Docket Item # 6
BAR CASE # 2017-00307

ISSUE: After-the-Fact Alterations
APPLICANT: TM Design Build
LOCATION: 206 North Fayette Street
ZONE: CRMU/M Mixed Use

BAR #2017-00307
206 North Fayette Street

Figure 1: Front facade

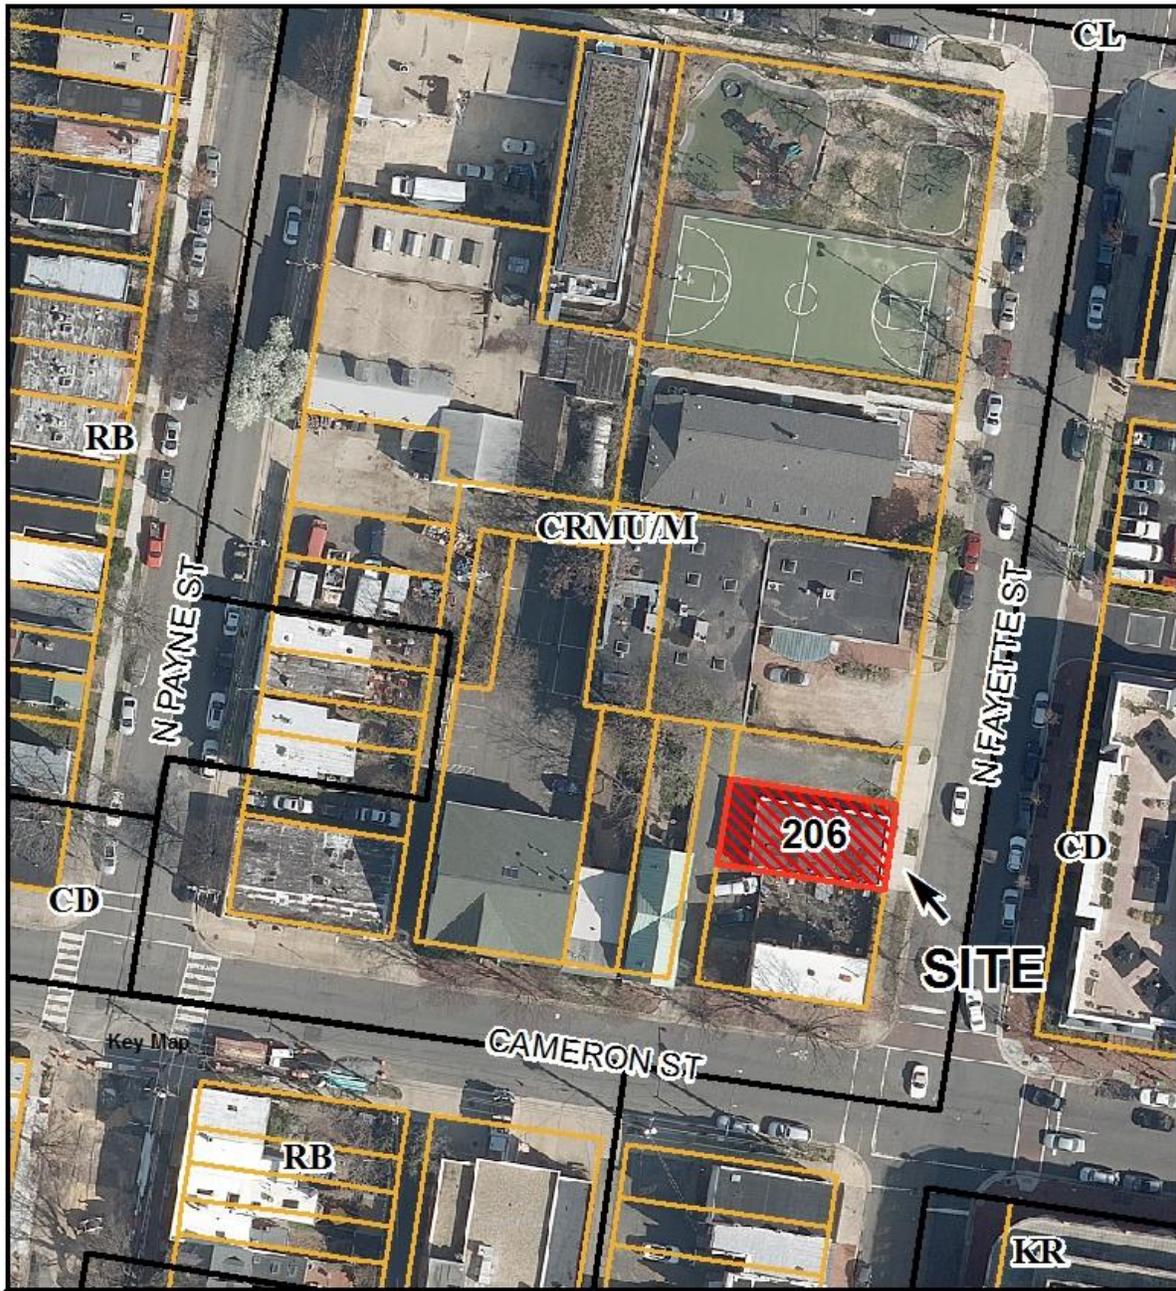
Because the awning was previously approved by the BAR, staff could have administratively approved the replacement of the canvas awning (Figure 1) but is included here to provide project context. Exterior security grilles are strongly discouraged in the BAR's *Design Guidelines* and the grilles at the subject property may have been installed prior to creation of the District in 1983, as there is no record of Board approval. Staff recommends their removal for recycling.
